MEMORANDUM

TO: CHAIRMAN LA PLACA AND THE EPS COMMITTEE
FROM: GEORGE FRANCO, DIRECTOR OF PUBLIC SERVICES
SUBJECT: PROPOSED PARKWAY TREE REMOVALS AT 516 NORTH
LINCOLN STREET
DATE: NOVEMBER 13, 2013

TO: ROBB MCGINNIS, COMMUNITY DEVELOPMENT DIRECTOR
FROM: JOHN FINNELL, VILLAGE FORESTER
CC: GEORGE FRANCO, DIRECTOR OF PUBLIC SERVICES
SUBJECT: TREE PROTECTION – 516 NORTH LINCOLN STREET
DATE: SEPTEMBER 13, 2013

SAID PLANS ARE NOT APPROVED. Plans need to be revised as noted below.

Tree Plan
X Removed = 2 STORY
BRICK & FRAME

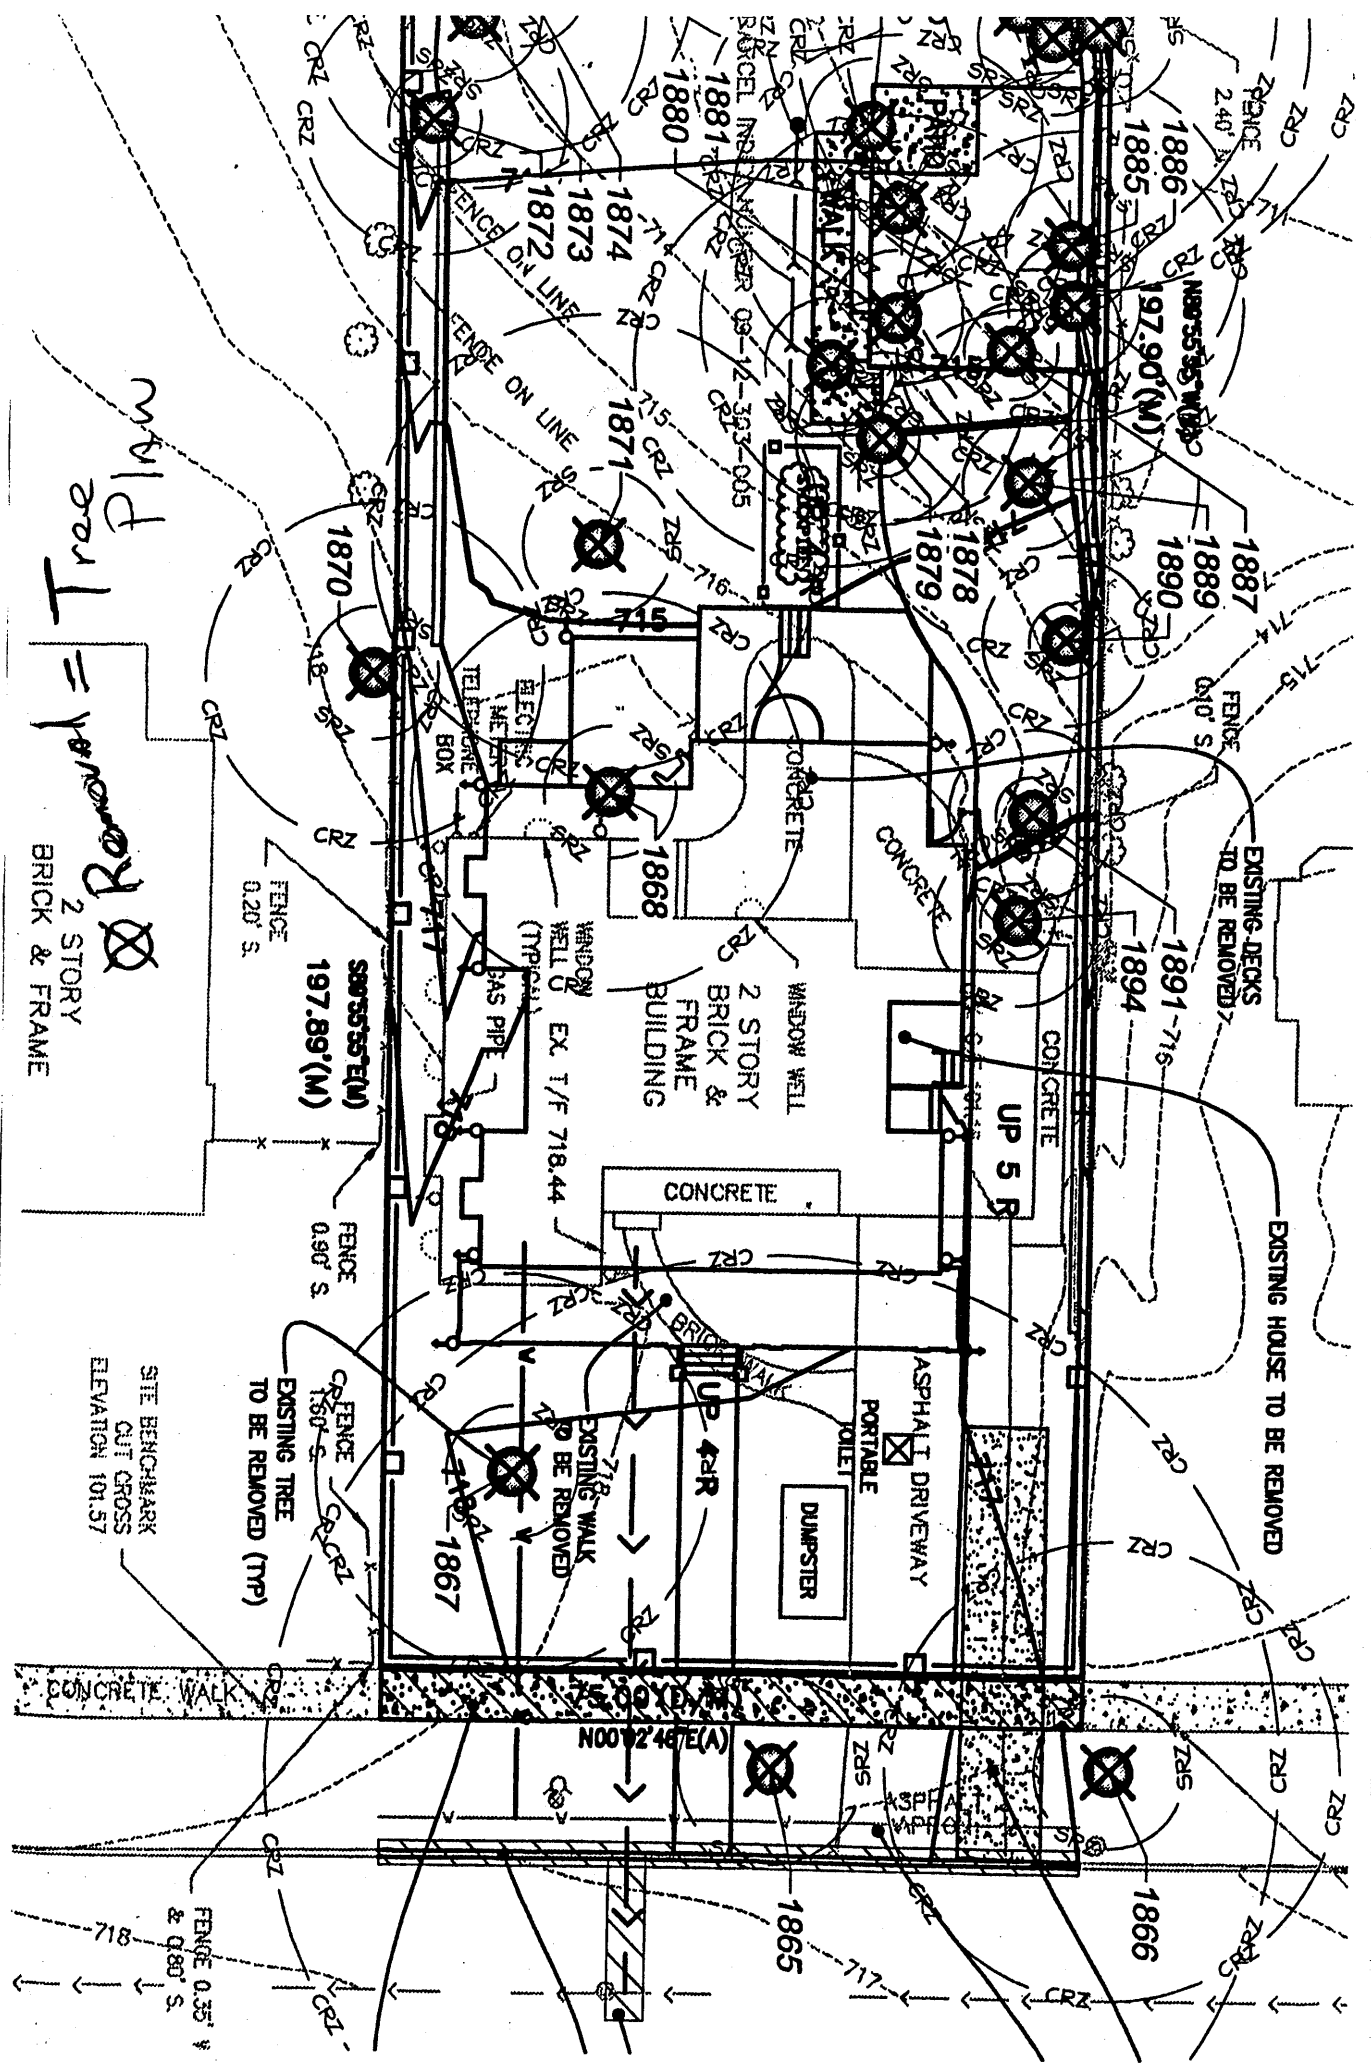
- The location of all trees in excess of eight inches (8") in diameter measured at breast height (dbh) on the property and within fifteen feet (15') of any property line of the property (collectively the "protected trees"); **(not completed, several trees on within 15' of the property line are not on the plan)**

- A clear delineation of the perimeters of each construction activity area and each root protection area; **(not completed, this will be completed by showing temporary storage areas outside of Tree Protection Zones)**

- A certification from an arborist that the tree preservation plan incorporates all reasonable steps necessary to minimize damage to trees on property adjacent to the property. **(This has not been submitted and should also be on the civil plans and not as an attachment)**

2. No permission is given to remove any public tree or trees. Trees #1865 and #1866 on the civil plans are public trees, but are shown as proposed removals.

3. Tree #1870 on the civil plans appears to be on the property of the south neighbor yet is located on the property. This should be corrected.
 4. Clarification of the driveway apron location is needed. The location of the driveway apron is required to be at a minimum of 10' from any portion of the apron to the closest edge of a parkway tree; or within the limits of the existing driveway apron. The width of the driveway should not be expanded if the expansion is within the 10' minimum distance from the parkway trees. This should be confirmed on the plan and field verified by Village staff prior to installation.

7. The Proposed utilities (water, sanitary, storm, etc.) are within the critical root zone of the parkway trees. Locate the proposed water and sewer lines outside of the Tree Protection Zone or install the sewer and water utilities using trench-less methods. **Auger through the entire Tree Protection Zone, locate pits outside of the Tree Protection Zone. All work in the TPZ should be designed and performed to minimize damage to tree and root systems**
